MEMORANDUM

To: Montgomery Township Zoning Board of Adjustment

Re: **Michael and Jeanine Reilly Residence**
Floor Area Ratio Variance
17 Augusta Court
Block 30002, Lot 73
R-5 Single Family Dwelling Detached
Optional Development Alternative – Single-Family Residential Cluster 1

Date: February 5, 2024

Rear of Existing Dwelling at 17 Augusta Court

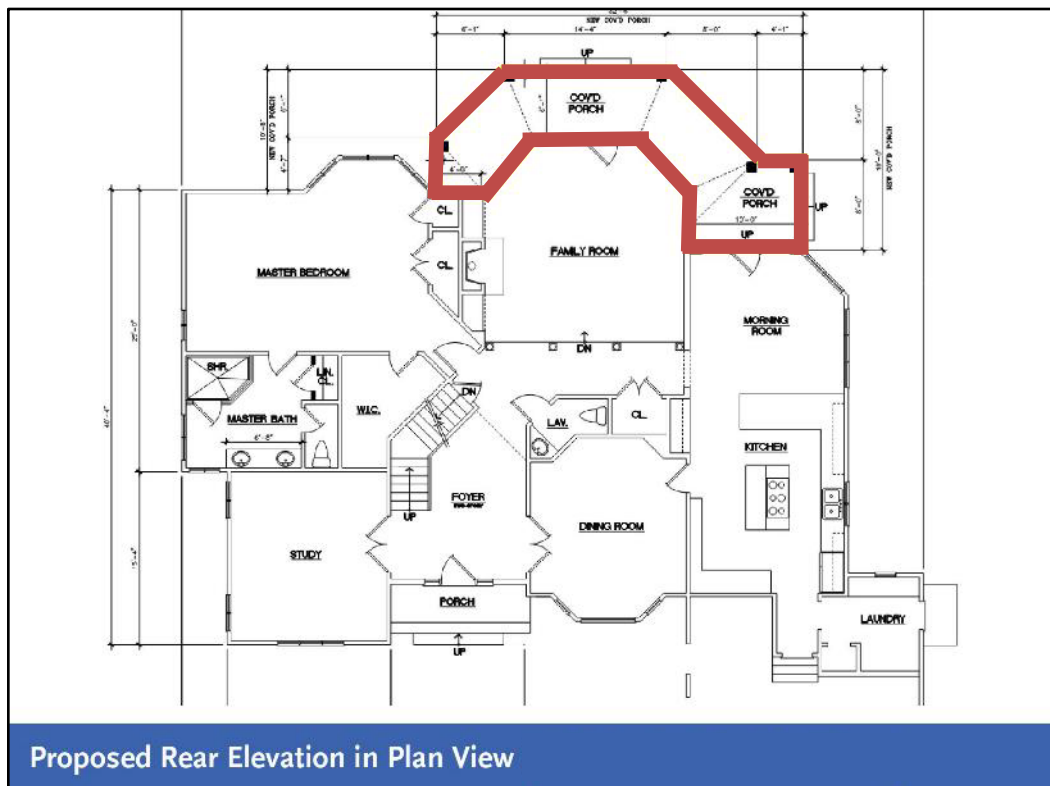
- 3.2 **Description of Addition.** The plans indicate that the addition will extend from the rear of the building, starting at the northwestern corner of the home and fanning out in a semicircular manner around the rear family room, encompassing approximately 60% of the rear wall on the ground floor. At its widest point it will extend 10 feet from the existing dwelling and will extend six feet and one inch backwards from the rear of the dwelling, with its total depth being 16 feet. Due to

the configuration of the rear of the dwelling the porch itself is never deeper than eight feet. Stone steps will lead to the covered porch from the rear yard, which will be open to the yard with a roof extending from the dwelling and supported by columns. Entry into the dwelling will occur through the two existing rear entrances, which are sliding glass paneled doors. The plans indicate that portions of the rear of the building are composed of stucco and will be replaced by horizontal siding.

An image of the rear of the building as it exists is provided below. The following page contains images of the proposed rear yard in plan view, and the elevation provided by the applicant.
